This letter is to serve as written testimony for the December 10, 2024, Linn County Planning Commission hearing on Planning File No. PD24-0237; a Condition Use Permit for a public trail on properties identified by the Linn County Tax Assessor Map No. T12S, R02W, Section 11AC, Tax Lot 1200 and T12S, R02W, Section 11BD Tax Lot 2000.

As outlined in previously submitted testimony by NIMBY NBR, LLC and as further reiterated below Planning File No. PD24-0237 fails to demonstrate that the proposed use complies with the decision criteria of Linn County Development Code (LCDC) Section 933.260(B)(1 – 5)(9) and as such should be denied.

This study has been performed for submission to Linn County. The purpose of this study is to identify the impact of the proposed mid-block location of the recreational development and associated bridge crossing and suggest alternatives.

Figure 2 Trail 4, Section 1 of the Lebanon Trails Plan with proposed trail alignment mark-ups.

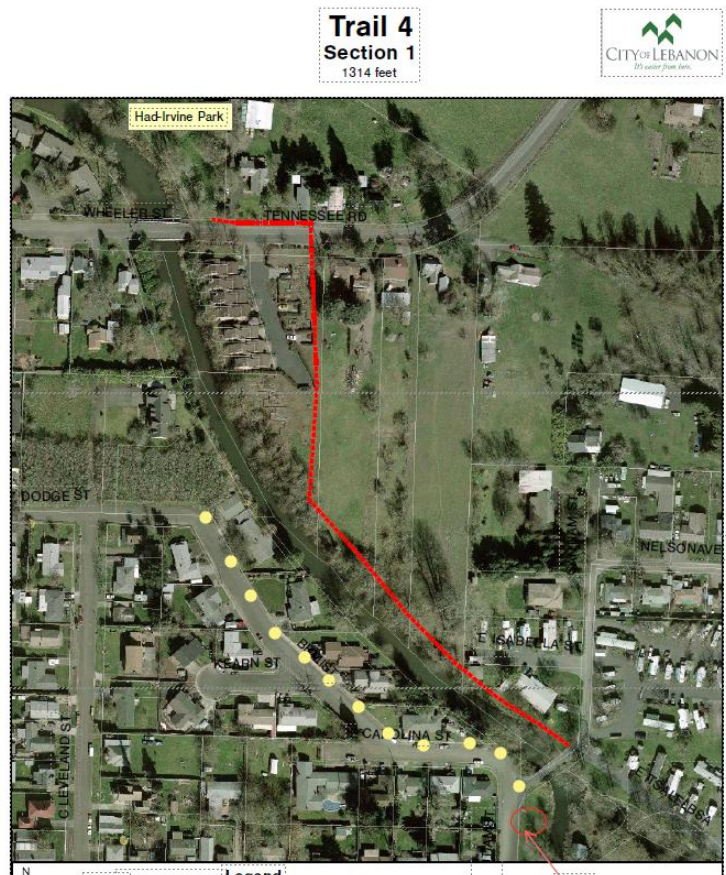
4. The County cannot ignore the proposed use also conflicts with the City's Comprehensive Plan. The Lebanon Trails Strategic Plan, Parks Master Plan, and Lebanon Transportation Plan all depict the Trail 4, Sections 1 and 2 nearly entirely along the **east of the Santiam Canal** and entirely outside of the Residential Low Density Zoning District as depicted below:

- *Trail 4 Section 1 begins at the entrance to Had-Irvine Park on Wheeler Street, then travels east along the Wheeler Street right-of-way for a short distance before turning south and proceeding along the eastern edge of the Bridgeport Condominiums, then leading alongside the Albany-Santiam Canal in a southeastern direction, ending at the Santiam Street Bridge.*

Figure 3 Trail 4, Section 2 of the Lebanon Trails Plan with proposed trail alignment mark-ups.

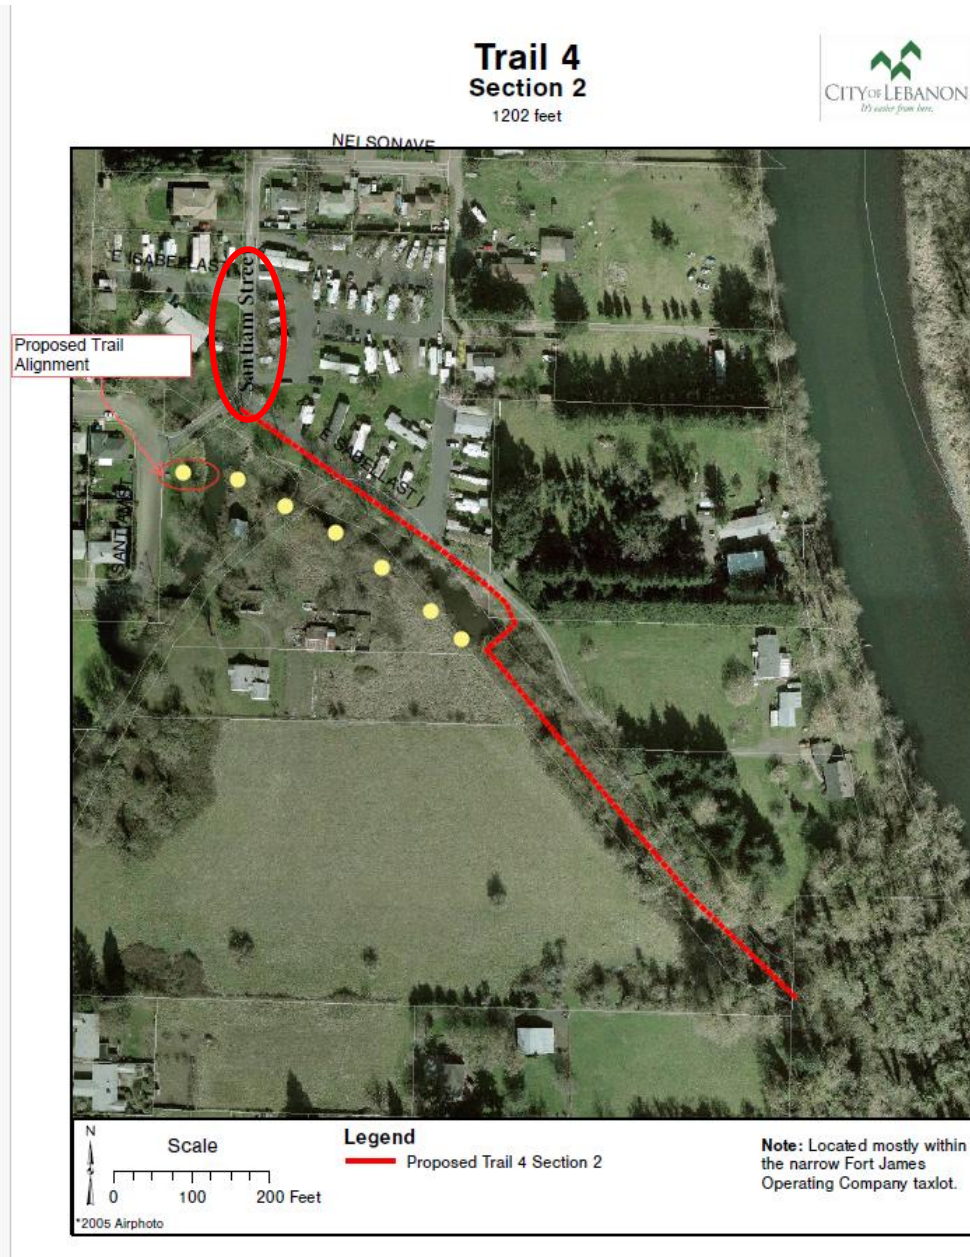
- Trail 4 Section 2 begins at the southern end of Trail 4 Section 1 near the Santiam Street Bridge, and follows the Albany-Santiam Canal in a southeast direction, ending at (...) River Park to the north.

Exhibit 1 – Approximate location of pedestrian bridge terminus and likely path of pedestrians without positive guidance.

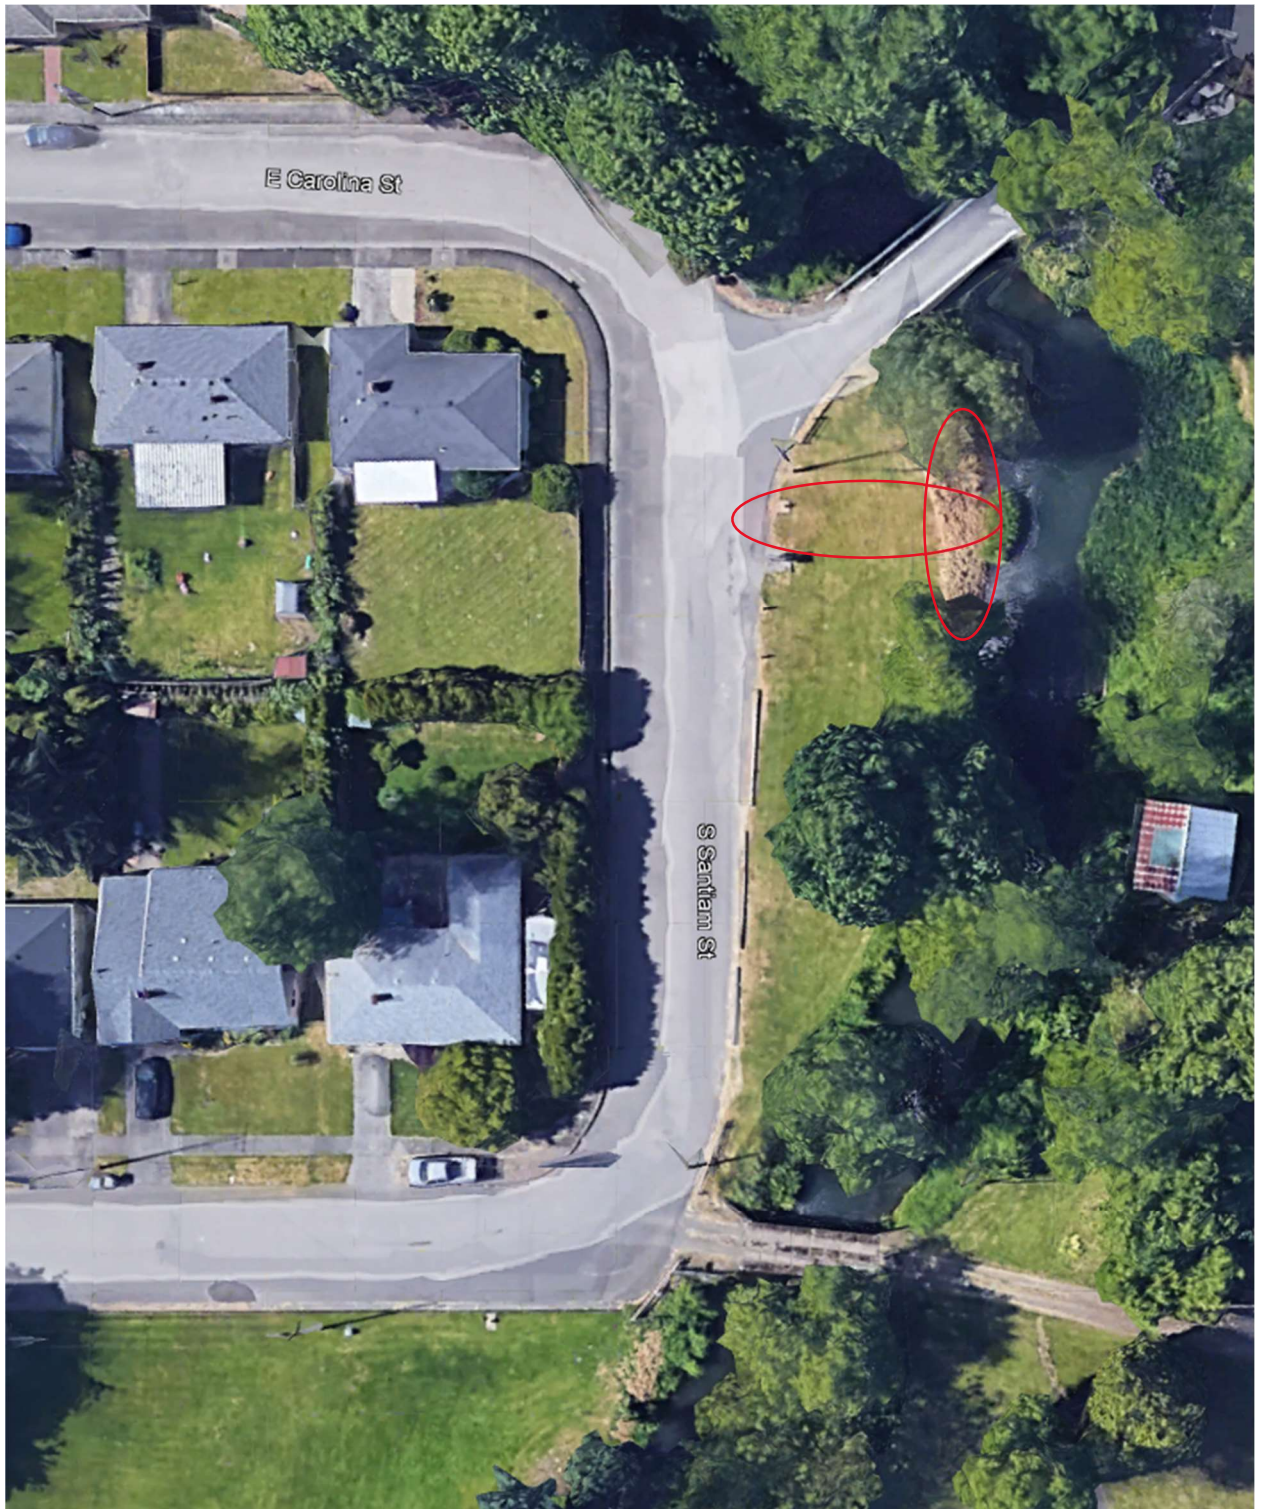
The proposed pedestrian bridge would end in the middle of an unimproved section of Santiam Street. The approximate location of the bridge terminus is shown earlier in this report. There are no plans addressing how pedestrians and cyclists would be accommodated at the end of the bridge. This is problematic for several reasons:

3. It is unclear how the plan will tie into the future trail extensions planned to the north will connect. As shown in Figure 2, the trail plan shows the trail located on the other side of the canal. A better location for the crossing would be closer to where the trail will continue. At the proposed location, pedestrians will need to cross the canal twice to get back to the trail as planned on the northeast side of the canal. The planned bridge has not considered how future connections will work or where they will be located.

4. Relocating the bridge or combining the bridge with a future public street crossing to access properties to the south. The original trail plan showed the trail to be located on the northeast side of the canal, rather than the southwest side of the canal. There are several locations along the canal where the bridge could be located. It would be reasonable to make this a condition of approval for the proposed trail realignment if the bridge is not moved.

5. Provide details of how the future trail connections will occur to ensure that the proposed bridge location and planned connections are consistent with future plans . It does not appear to be located well for the current plan.
